## PIC18F26/45/46K40 Family Silicon Errata and Data Sheet Clarification

The PIC18F26/45/46K40 family devices that you have received conform functionally to the current Device Data Sheet (DS40001816E), except for the anomalies described in this document.

## Data Sheet Clarifications

#### 1.1 44-pin TQFP package

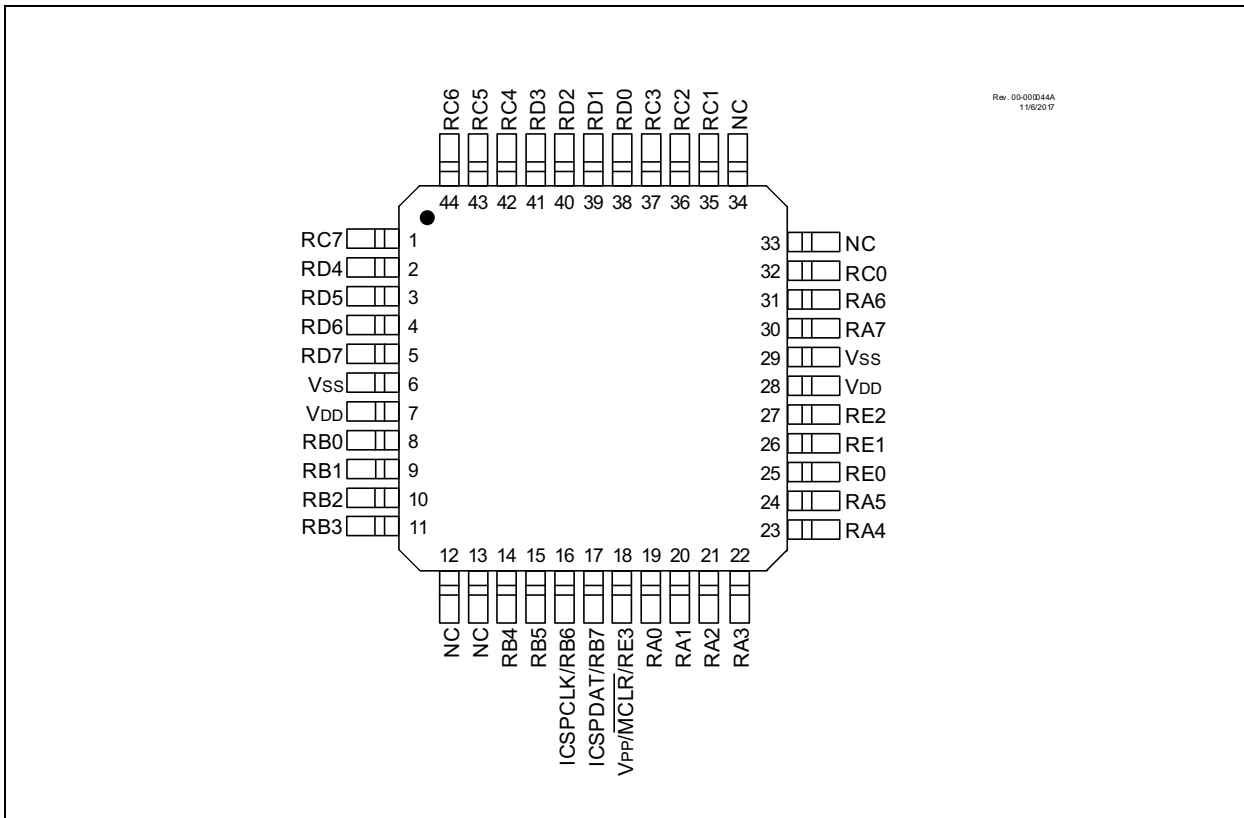
For the 44-pin TQFP, use the following pin diagram:

### 1.2 44-pin QFN package

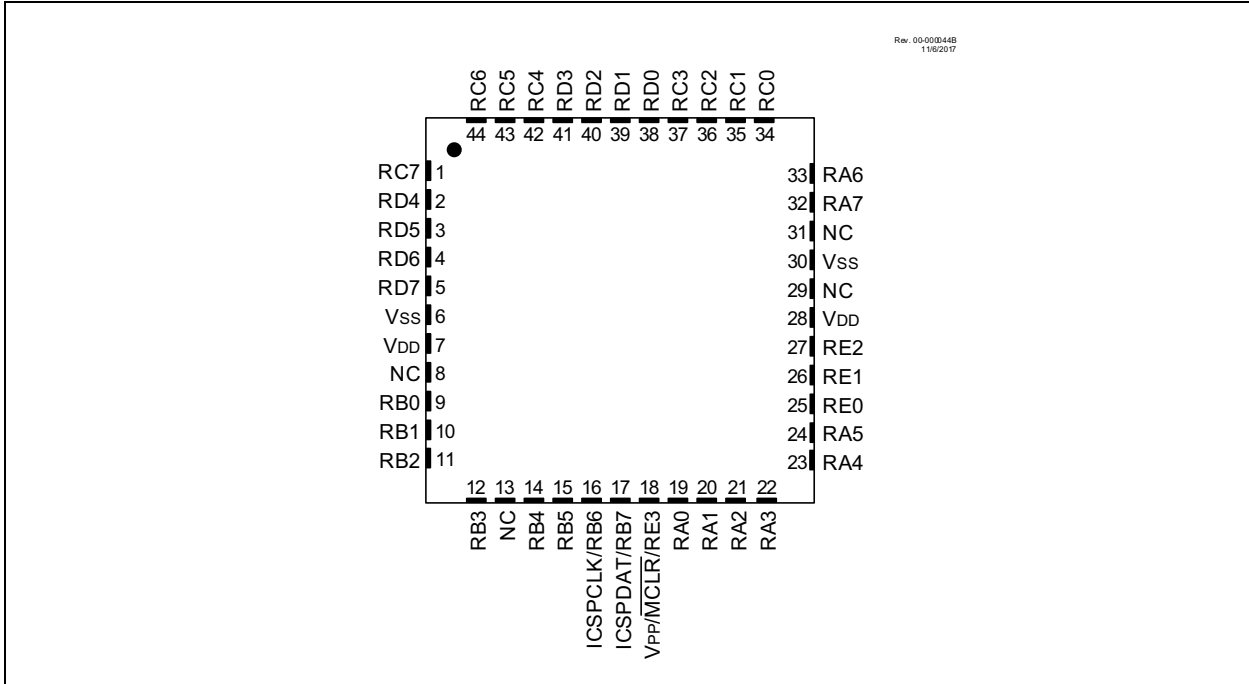
For the 44-pin QFN, use the following pin diagram:

### 1.3 40-pin UQFN package

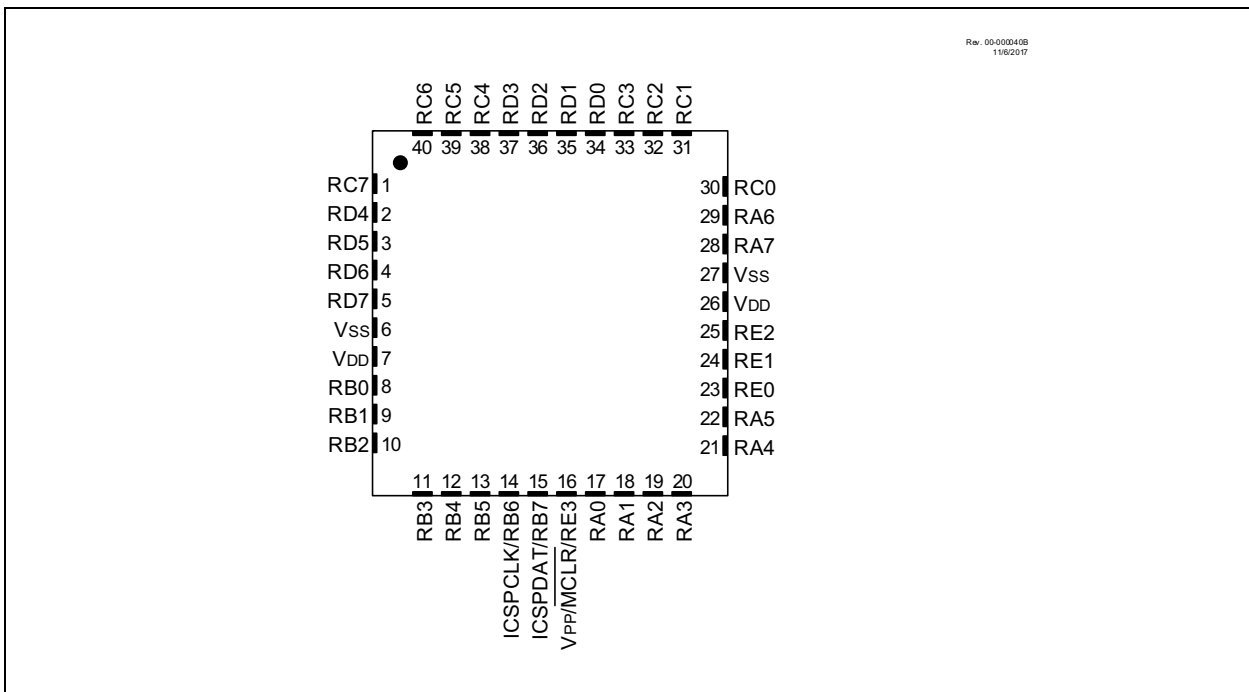
For the 40-pin UQFN, use the following pin diagram:
